Product Change Notification: PCN-26-289679

AM WIRE PIN 20-17 .013 BR

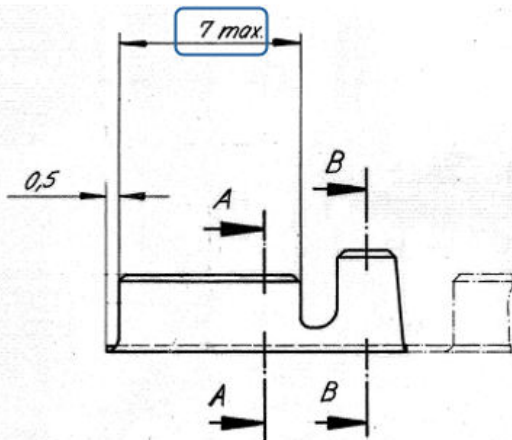
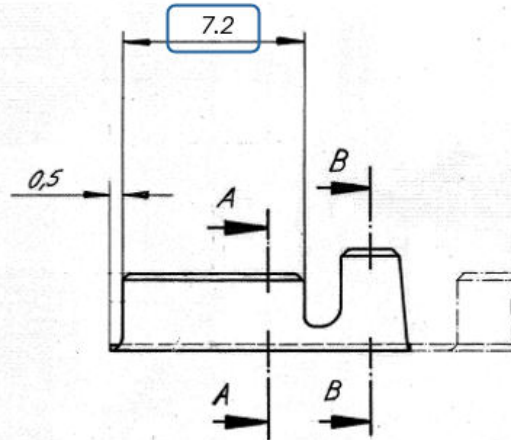
Dear valued Customers, to support long-term product availability and maintain a robust manufacturing process, selected dimensions have been updated. The updated drawing continues to meet the specified functional and performance requirements of the product

Dimension was 7mm Max

Dimension updated to 7.2mm

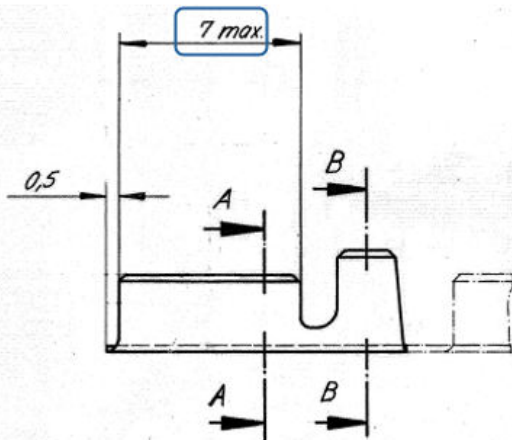
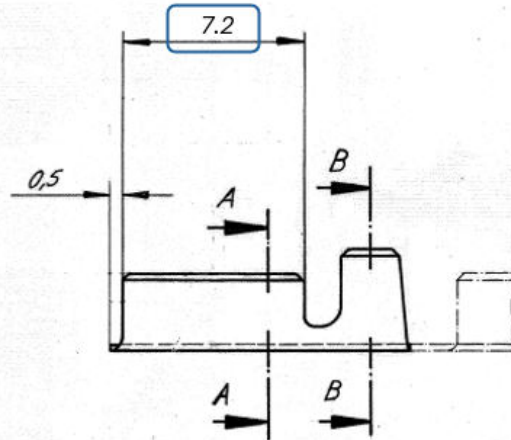
Dear valued Customers, to support long-term product availability and maintain a robust manufacturing process, selected dimensions have been updated. The updated drawing continues to meet the specified functional and performance requirements of the product

Dimension was 7mm Max

Dimension updated to 7.2mm
